ENVIRONMENTAL ASSESSMENT STATEMENT

Guam Hilton Hotel Dredging Project

Public Notice Number PODCO-0 1054-SD

Tumon Bay, Ypao, Territory of Guam

# BEACH DEVELOPMENT PLAN

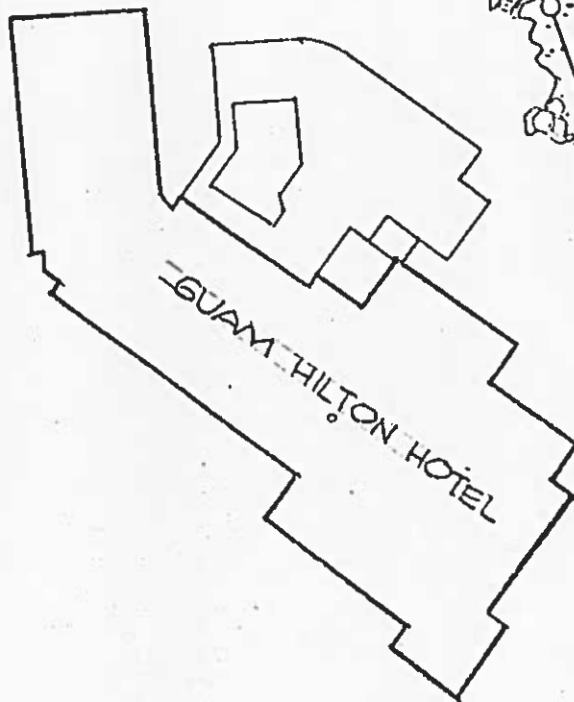
The North end of the beach development plan is poorly designed as the sand fill would be washed out of the rock breakwater. The only purpose served is again to establish rights to the area outside of the Hotel property lines.

I have enclosed herewith a copy of an environmental assessment statement which includes a marine survey. The biologists who conducted the marine survey have advised us that the sand would not remain behind the proposed rock fill and we have accordingly deleted this part of the proposed project. There are several other modifications recommended by the marine biologists that we have adopted and these are also outlined in the environmental assessment statement attached.

SHEET NO. 4

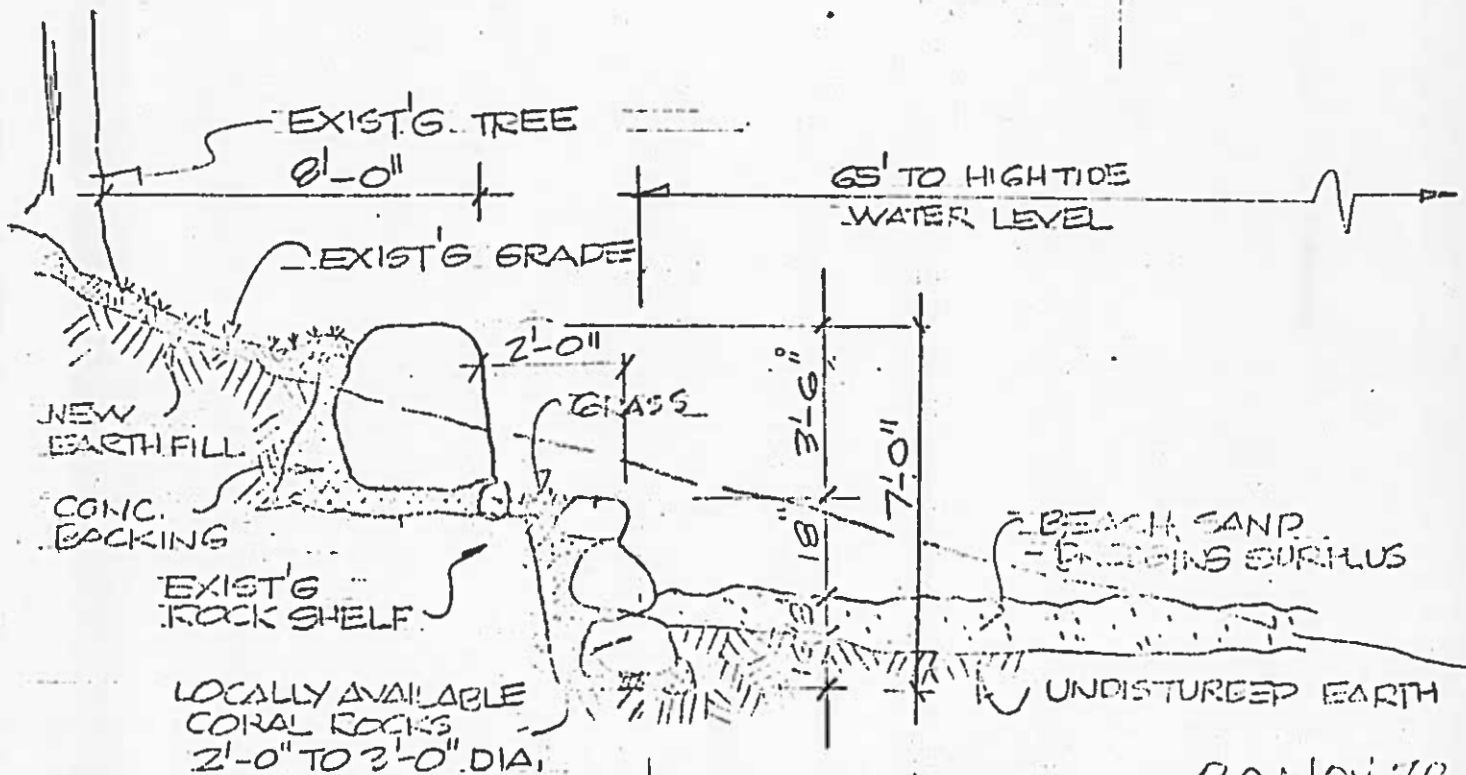
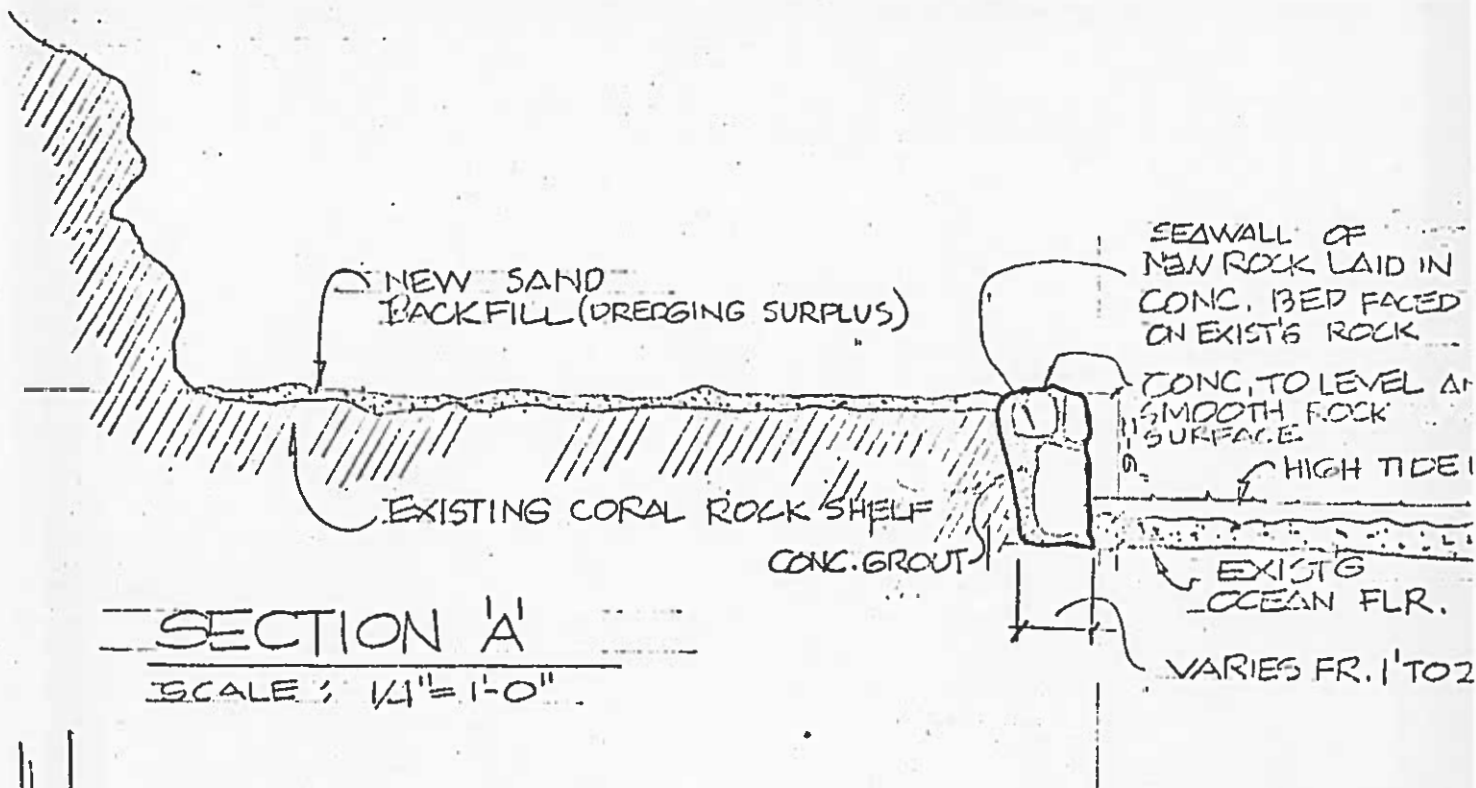
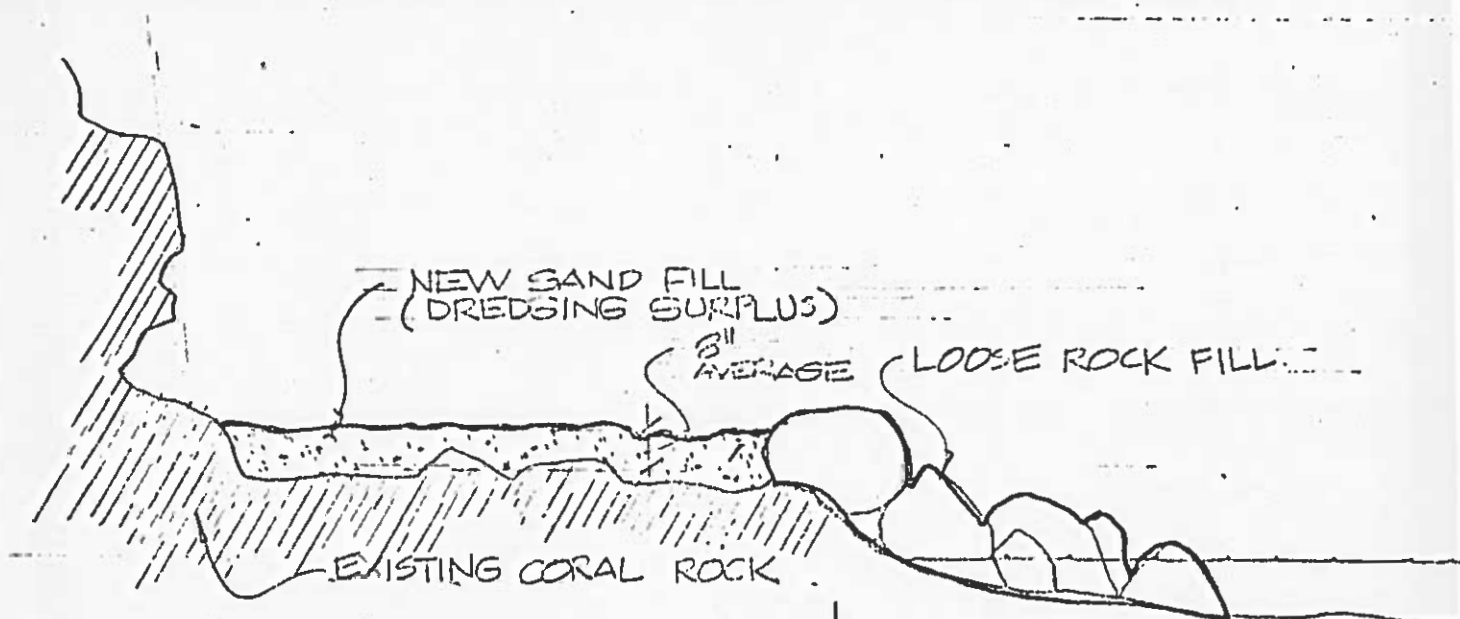
According to sheet 4, cross section A, a vertical seawall of new rock will be constructed in a concrete bed faced on an existing rock wall. The same procedure presumably will be followed at cross section E. We recommend this new seawall not be of vertical construction, but rather of sloping construction seaward with a slope of 1 on 2 or 1 on 3. Such a slope would not only aid in preventing erosion, but would also provide additional habitat for marine animals. A sloping seawall should not be of smooth concrete construction.

The applicant also proposes to construct an offshore barrier (cross sections C and D) of loose rock fill behind which sand backfill from dredging surplus will be placed on an existing coral rock shelf. Presumably this loose rock barrier will retain the sand placed on the coral shelf. The developer should provide assurance this sand backfill will remain in place and not be subject to erosion, either through the loose rock barrier, or by the periodic storm waves which occasionally sweep this area. If the sand backfill is subject to erosion, it would periodically need replenishment, thus requiring removal of sand from some other area, with possible degradation of the replenishment sand site.

The proposed project has been modified to eliminate construction of any additional rock walls or rock fill. As modified, the project will entail only the removal of sand and debris from an area approximately 200 feet by 200 feet and part of the dredged sand will be used to improve the existing beach. The surplus sand will be placed behind existing sea walls in order to retain the sand.

Also, the original plan to back fill the proposed loose rock barrier with sand has been deleted. The only additional dredging that will be done will be that required for periodic maintenance of the swimming area and the sand removed from the swimming area will be used to replenish any sand eroded from behind the sea walls.

SECTION 'F'

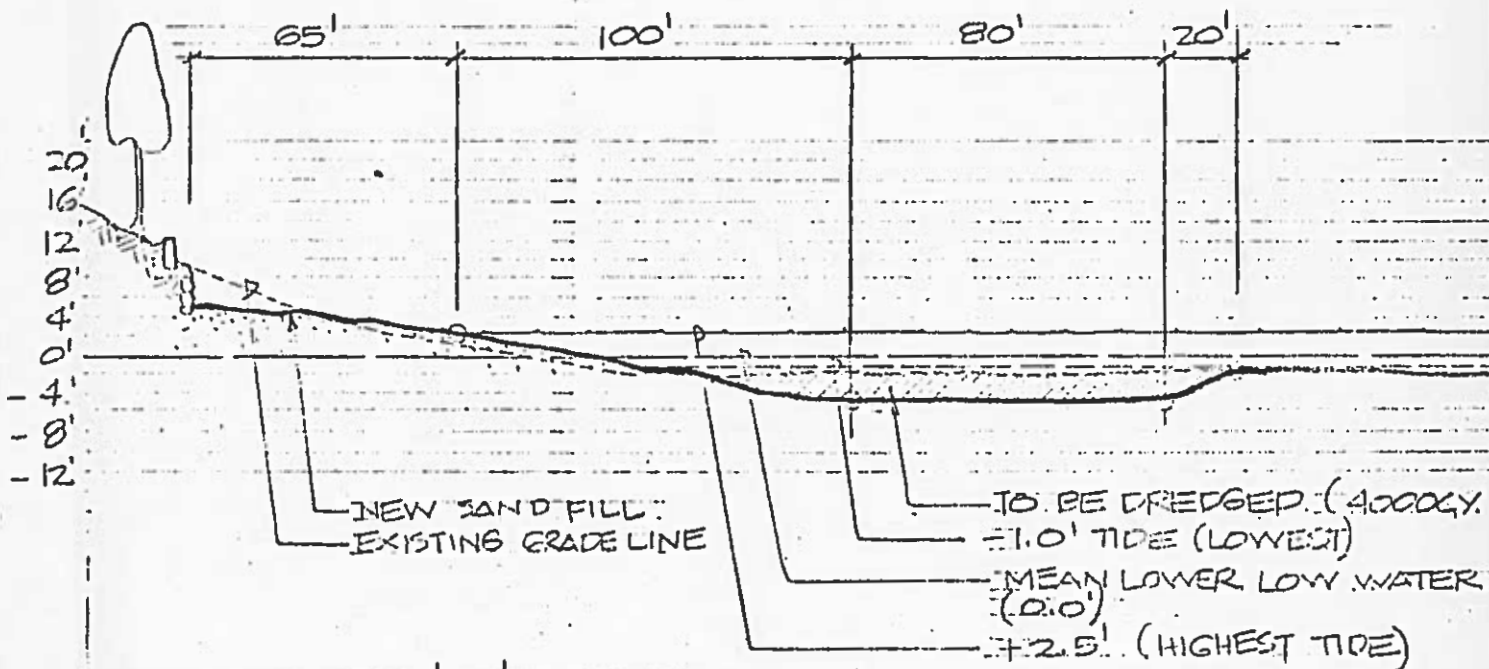
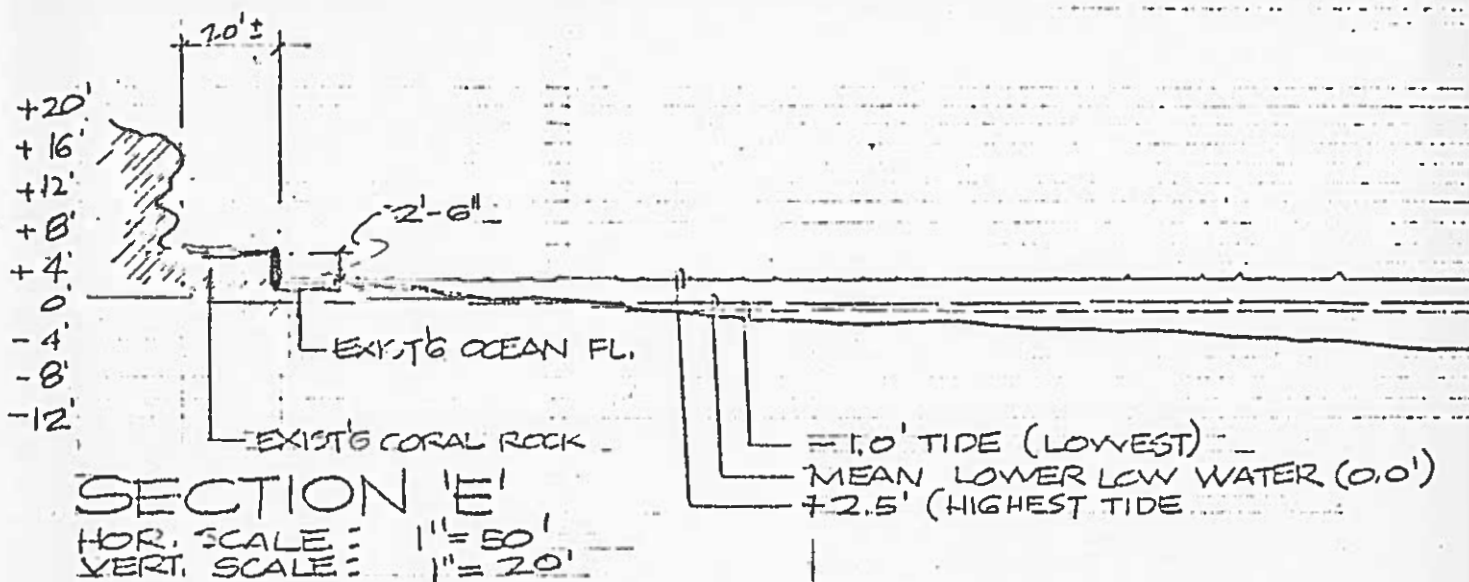
Section "F", Sheet #6, as submitted indicates 4000 C.Y. to be dredged although the actual calculated amount is slightly over 2000 C.Y. With beach sand selling at \$9.00 per cubic yard on Guam, and the proposal that excess material be removed from site, the indication is that Government materials will be used for private acquisition.
